**REVIEW BY FORT BEND COUNTY  
COMMISSIONERS COURT**

Permit No: 2017-13354

**Job Location Site:** 33058 Rogers Road, Fulshear, TX 77441

**PERMIT APPLICATION REVIEW FORM FOR  
CABLE, CONDUIT, AND POLE LINE ACTIVITY  
IN FORT BEND COUNTY**

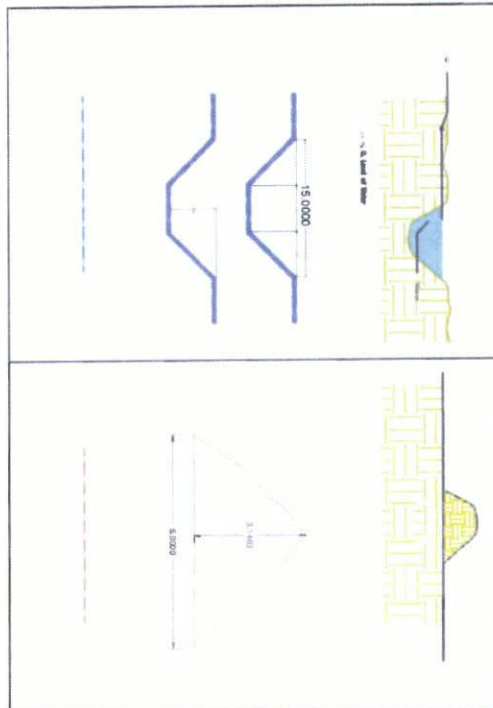
The Drainage District has reviewed the attached site plan for the property at 33058 Rogers Road. The site is adjacent to Brookshire Creek and is within Zone "A" on the FEMA FIRM maps, so floodplain fill mitigation and conveyance mitigation were a concern.

The original plan called for a berm to be constructed across the full length and width of the property along Rogers Road and Pool Hill Road. To avoid blocking conveyance along Brookshire Creek and natural drainage pathways along Pool Hill Road, the owner agreed to only construct the berm west of the existing driveway and south of the existing pond (red line on attached layout). Per the attached email, all the dirt used to construct the berm will be excavated from a proposed ditch from the existing pond to the creek (blue line on attached layout), so no outside fill will be brought into the floodplain.

The proposed pipe from the ditch to Brookshire Creek should be coordinated with the Drainage District maintenance section. The property owner will be required to purchase the materials, and the Drainage District will install the pipe. The Drainage District has no objection to the proposed work as described above. Let me know if you have any questions.
